**SOILS AND GEOLOGY STUDY  
THE COMMONS AT FALCON FIELD  
PARCEL NOS. 43070-00-001 AND 430720-00-015  
WOODMEN ROAD AND HIGHWAY 24  
EL PASO COUNTY, COLORADO**

January 20, 2021  
Revised July 21, 2023

PCD No: SP-232

**SITE PLAN/TESTING LOCATION MAP**  
THE COMMONS AT FALCON FIELD  
EL PASO COUNTY, COLORADO  
FALCON FIELD, LLC

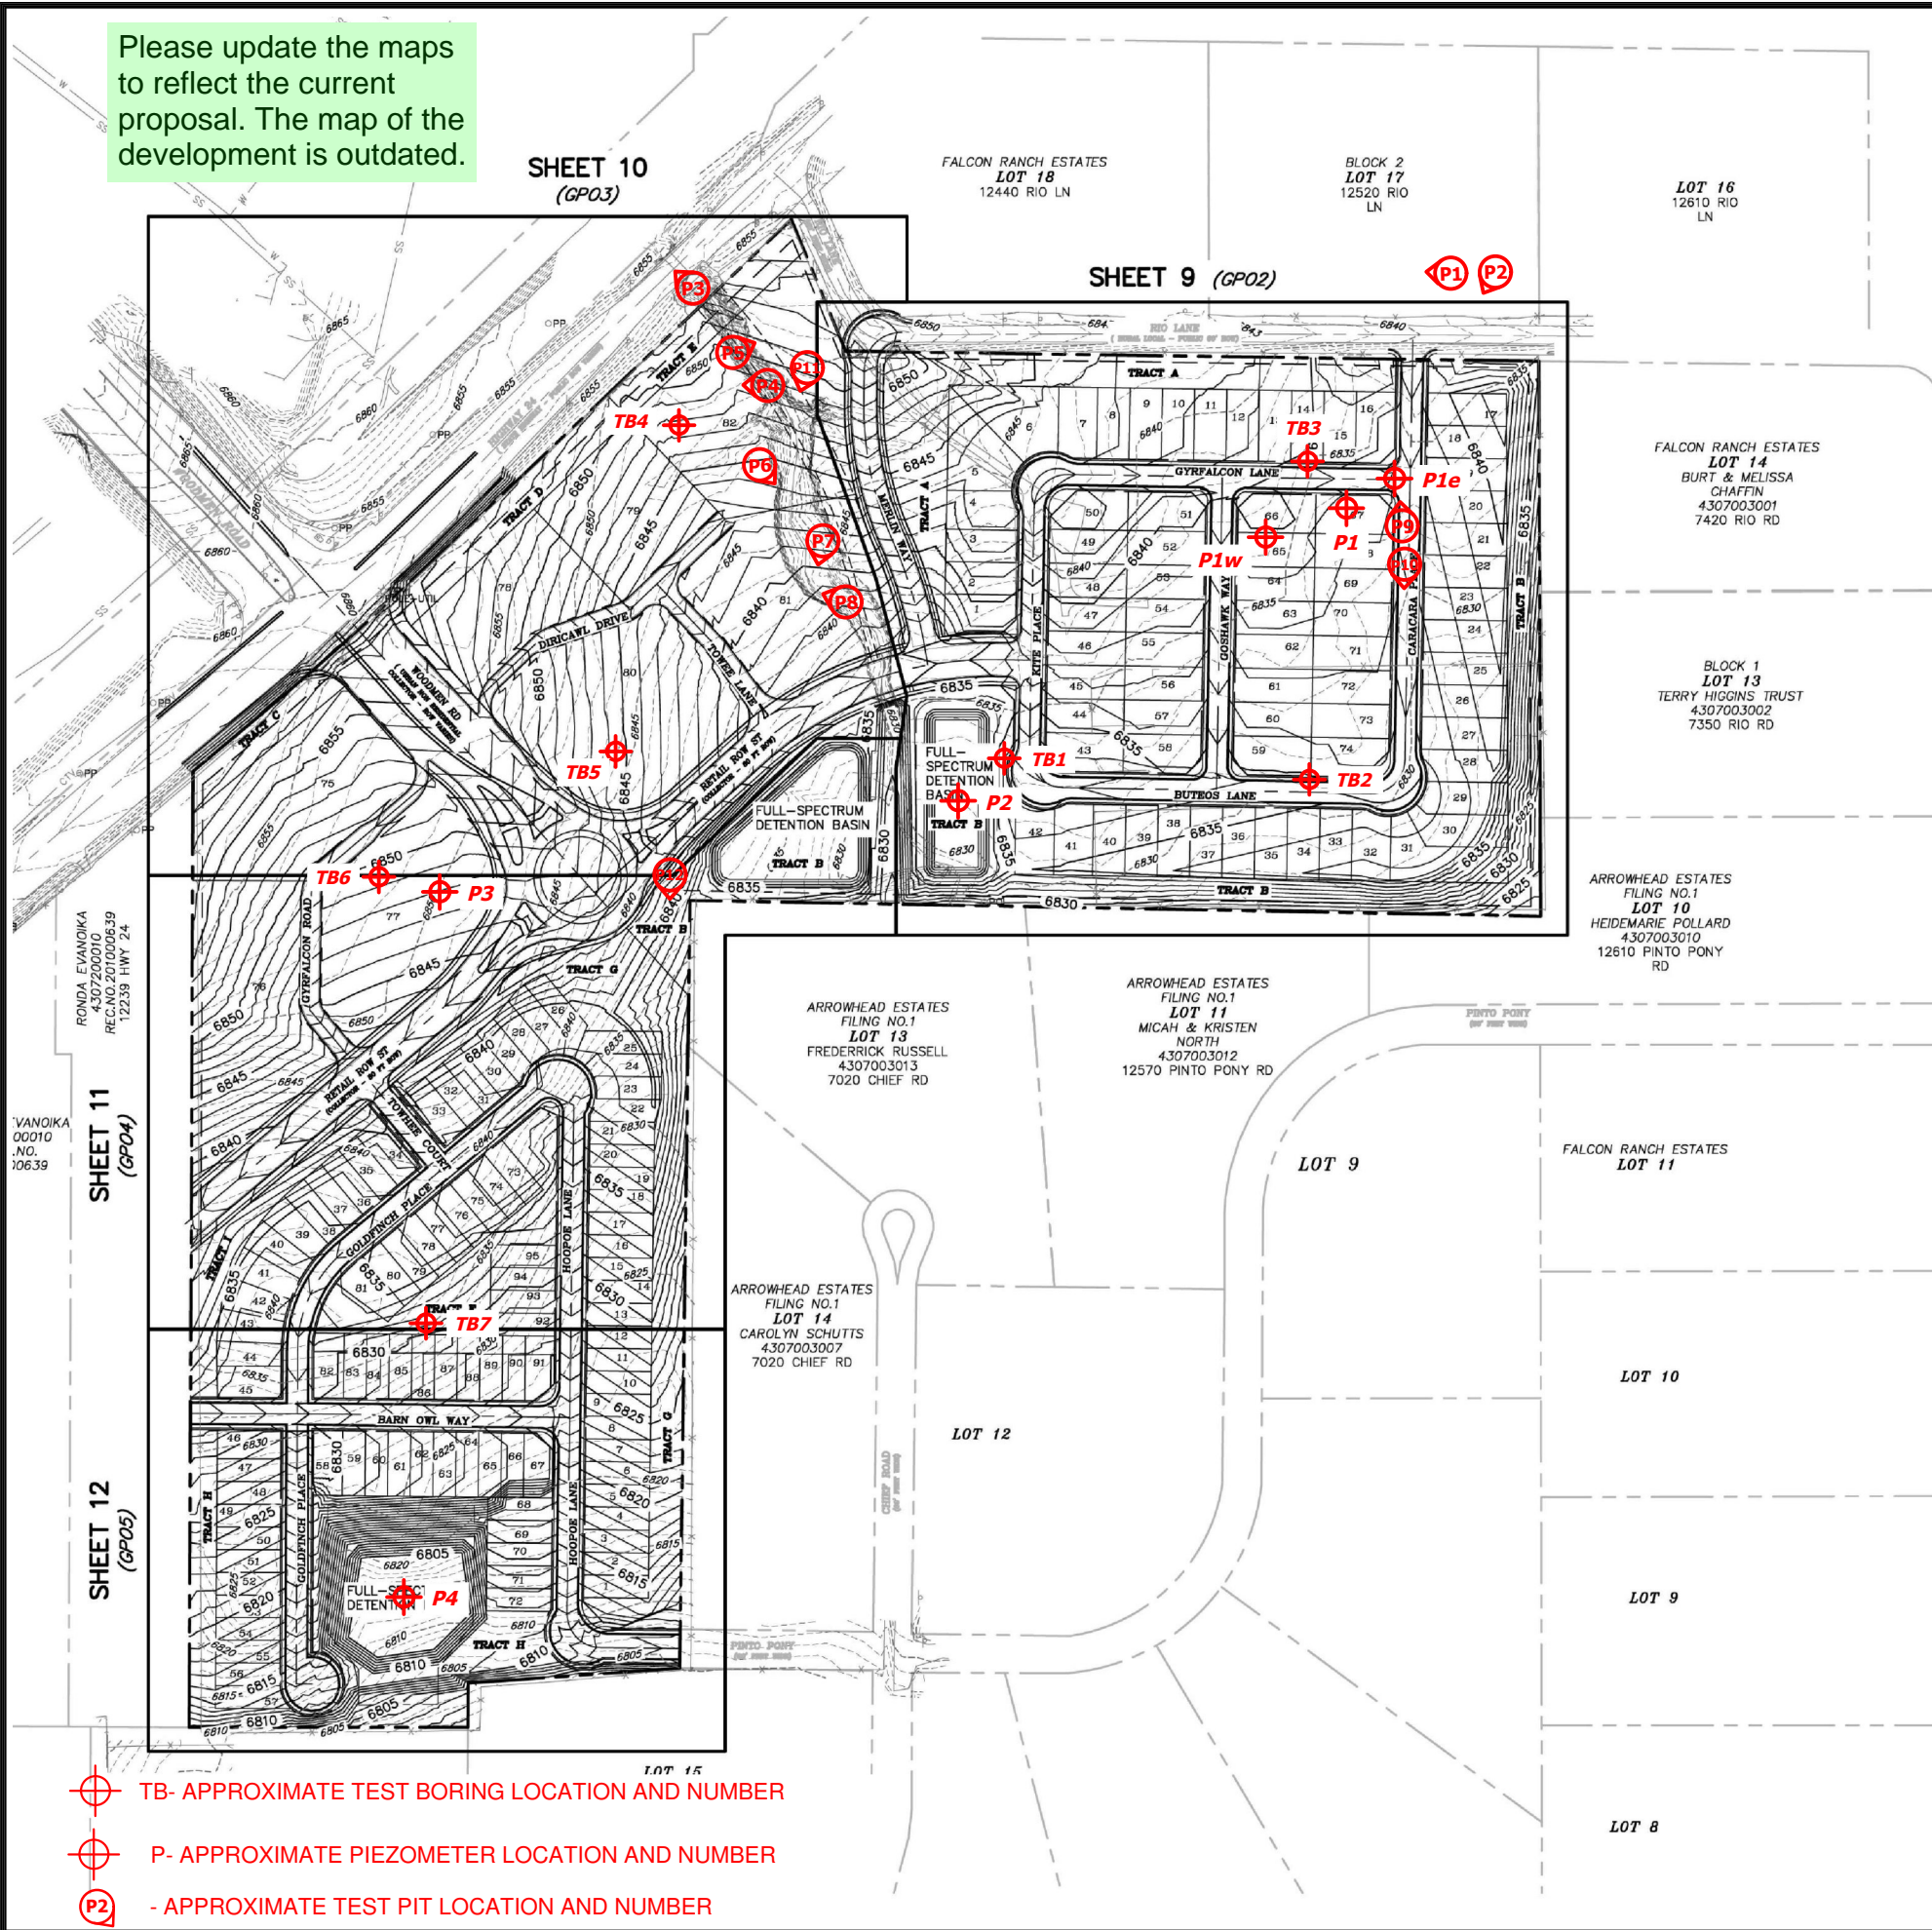
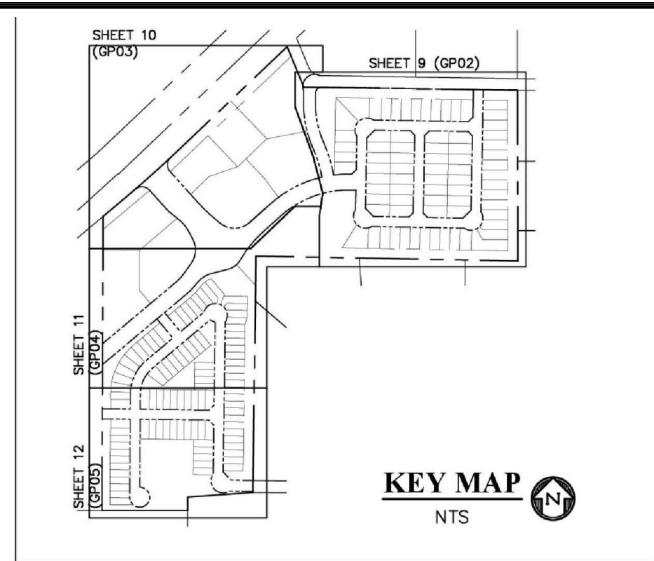
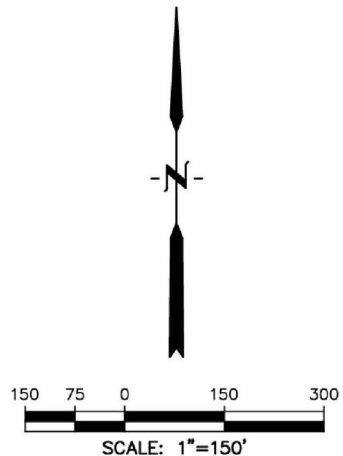
Please update the maps to reflect the current proposal. The map of the development is outdated.

**GEOLOGY/ENGINEERING GEOLOGY MAP**  
THE COMMONS AT FALCON FIELD  
EL PASO COUNTY, COLORADO  
FALCON FIELD, LLC

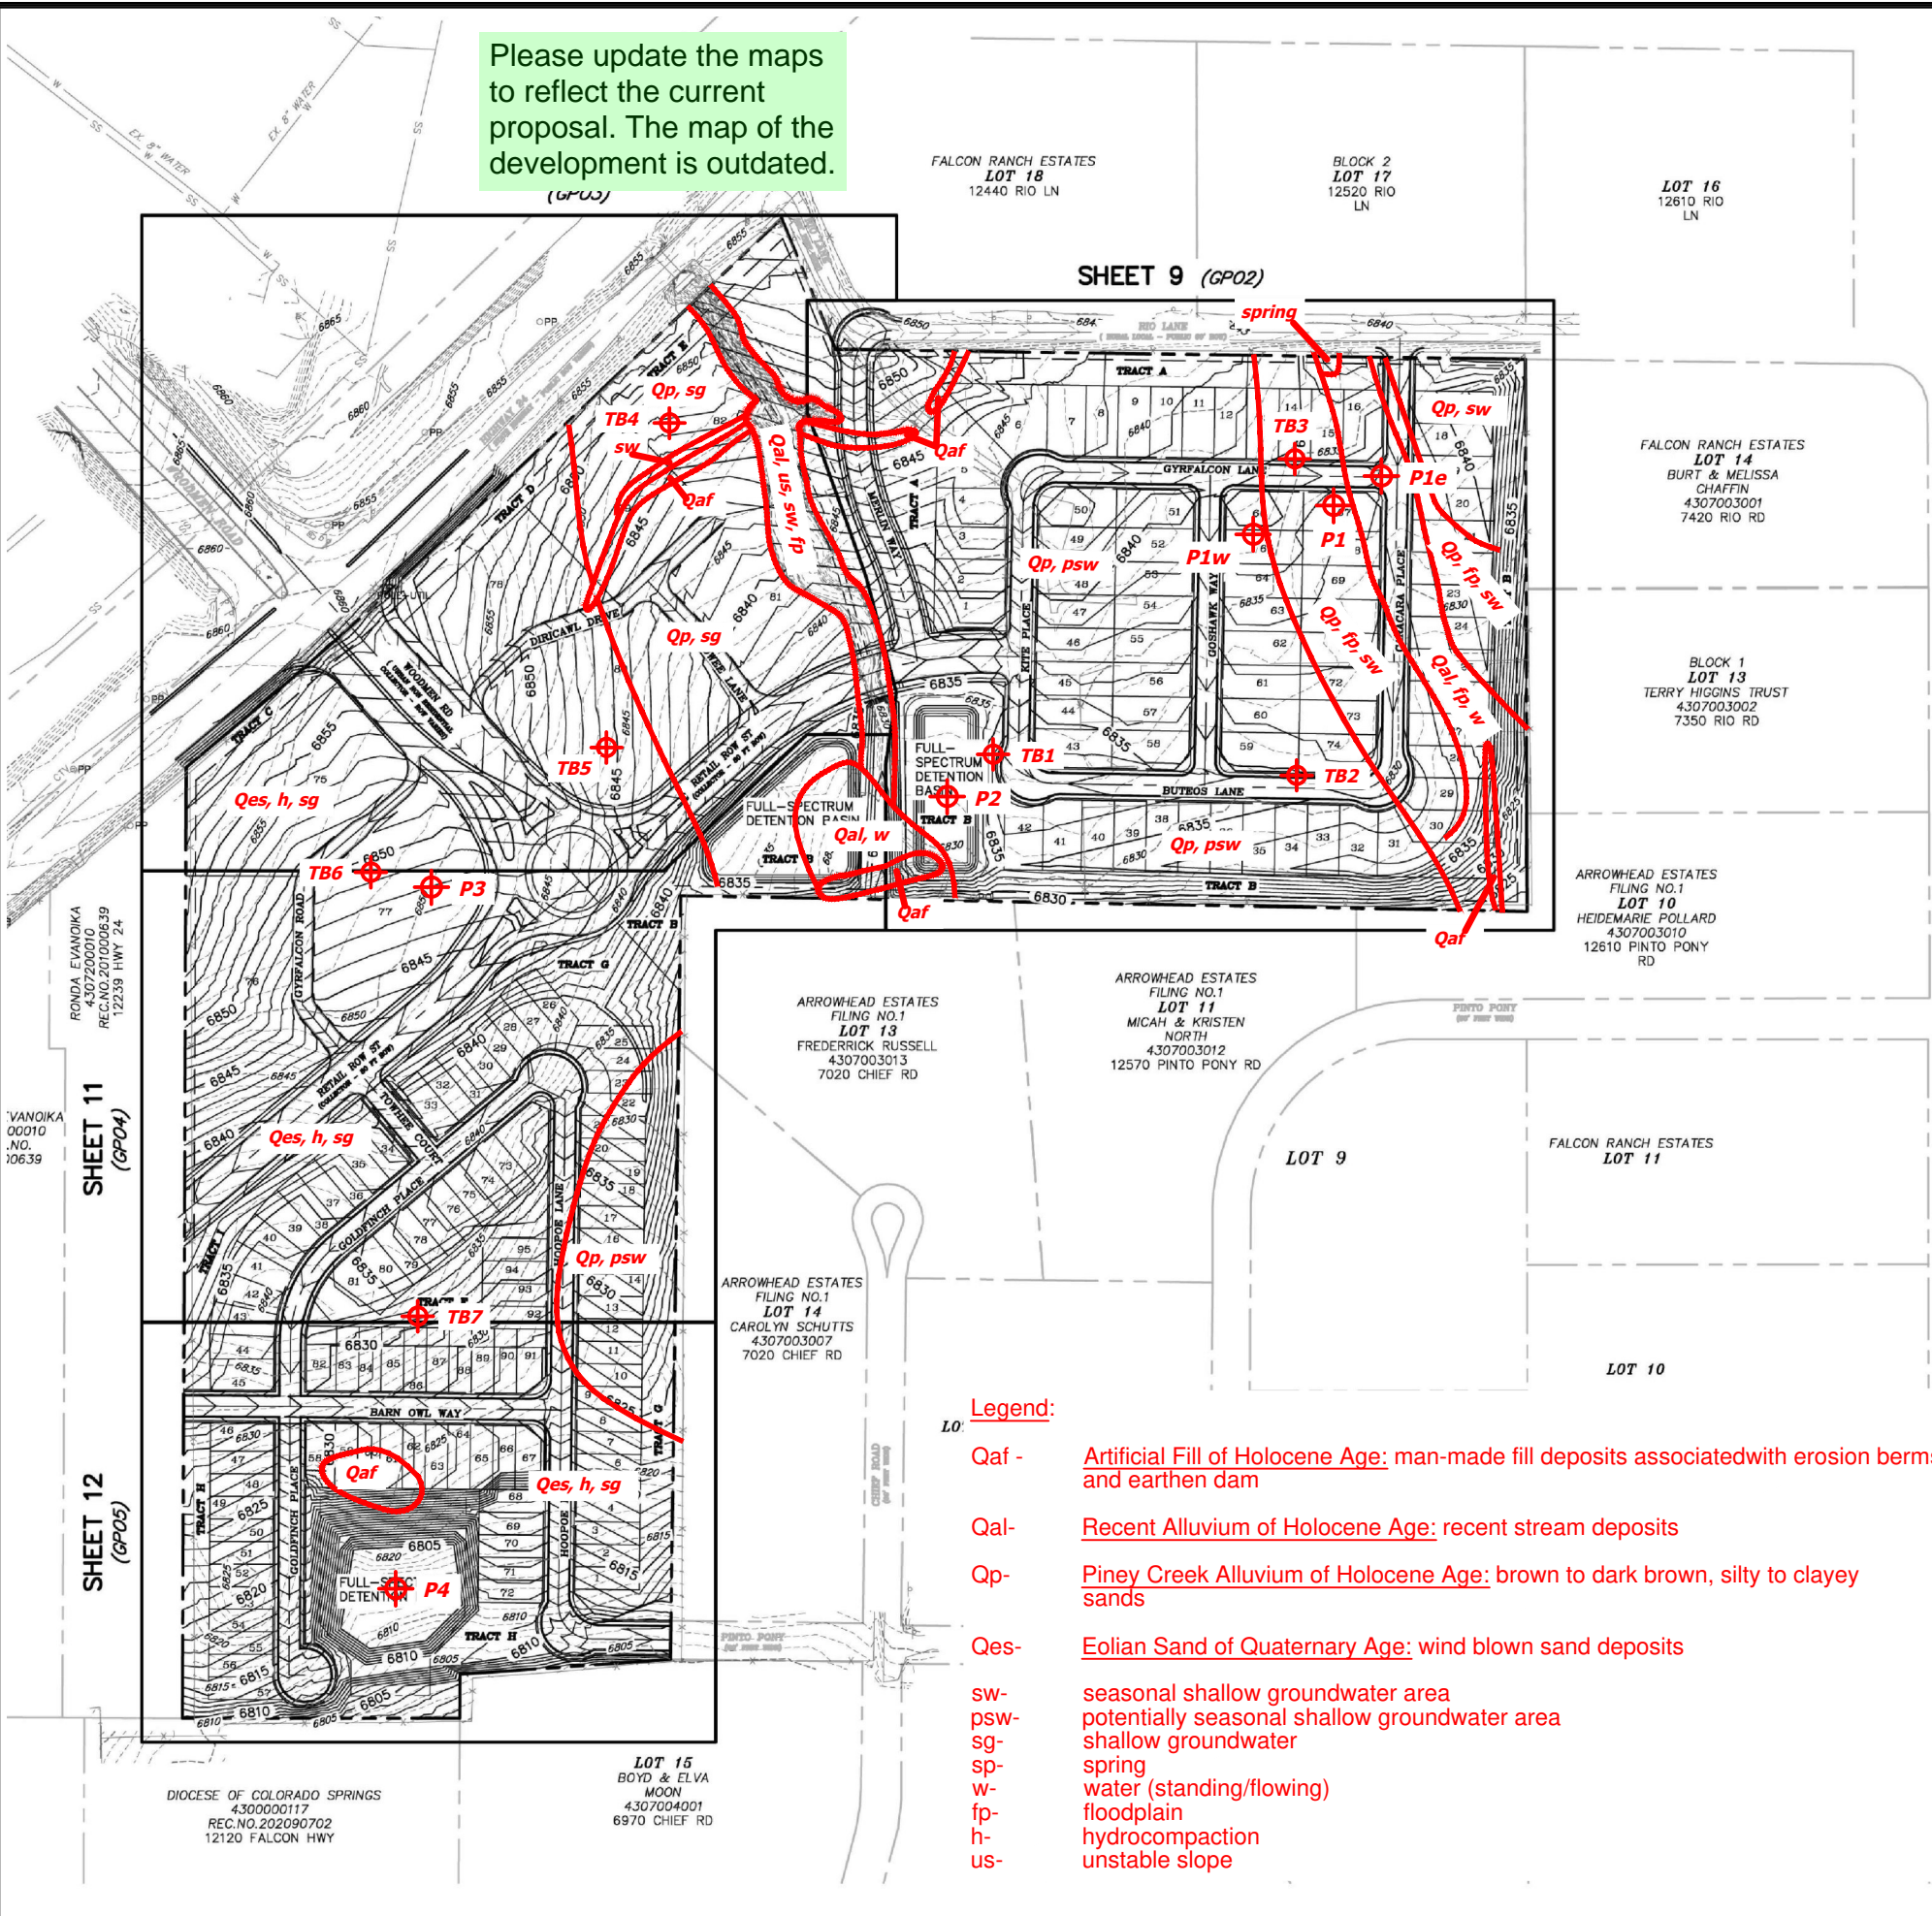
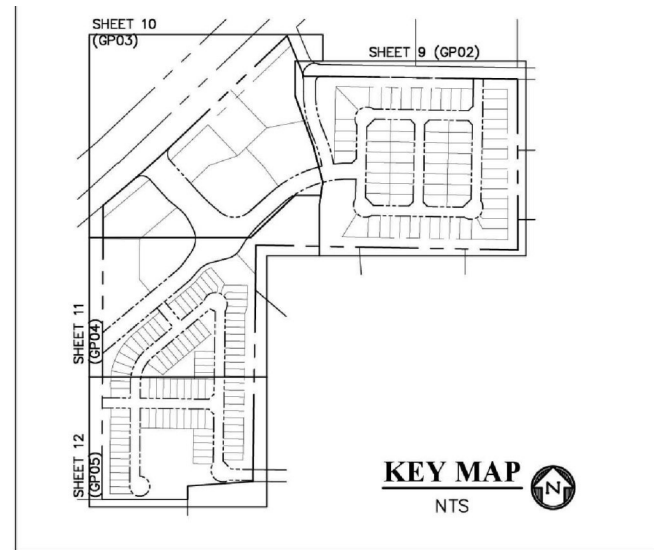
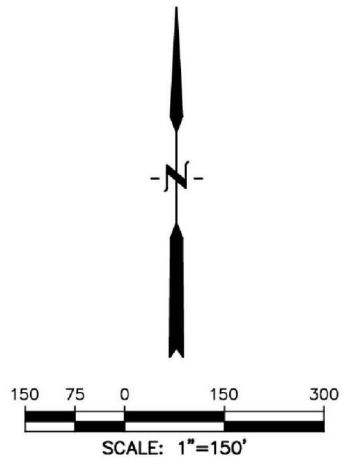
Please update the maps to reflect the current proposal. The map of the development is outdated.  
(GPOJ)
